**MINUTES OF THE MEETING
May 15, 2008**

**Seattle
Design
Commission**

15 May 2008

Figure 1: Freeway Park Landscape Plan

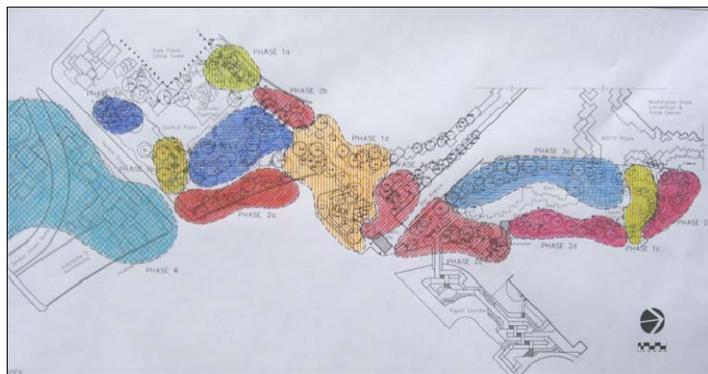
- Appreciate emphasis on creating a place for people and allowing the layers of time to be visible with plantings.
- What has been learned in 30 years concerning biodiversity and ecology, and what can be applied to this effort with Halprin's original wishes aside?

- New superintendent is fond of using native plants and the palette selected reflects this, creating the biodiversity that was absent before.
- Through replacement of plumbing and irrigation, will the system be forward thinking, or just a restoration of the current system?

- The concrete forms create the pathways which form the space. To what extent is the restoration bringing the concrete forms back to being part of the landscape?

- Concrete forms are essential to the parks design and choreographing of the space. The idea of creating an oasis where you are concealed from the city will not

- happen with the overgrowth, the concrete gives a feeling of being in the urban environment.
- Appreciate returning the original integrity to the park. See where the community would be excited and want to do it all at once, but support Parks Department decision for phasing. A communication plan that is interactive and dynamic and refreshed would be appropriate.

Figure 3: Skatepark Concepts

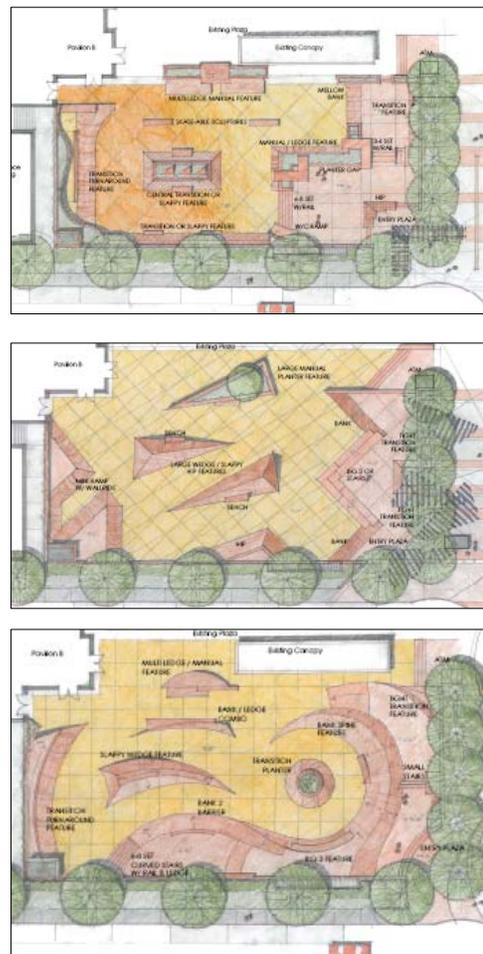
- SC is a place for innovation. Be new, bold, and adventurous. Is blending the concepts taking away the boldness of the design?
 - Softening some of the big statements and combining with the rectilinear elements of the other concept will keep the design fresh and bold. An exciting flow can be created by integrating the curvilinear form with the rectilinear elements.

- First and foremost it must work as a skatepark. The design needs to push the skateboarder's envelope as well as plan for future recreation needs.
 - A skateable art piece will definitely be incorporated into the park.

- Does the plaza have to be at grade, or can varying grades be added?
 - Existing grades will be used to add element changes to avoid tall walls. There will be a grade change in all three options between the zero grade plaza and the ends.
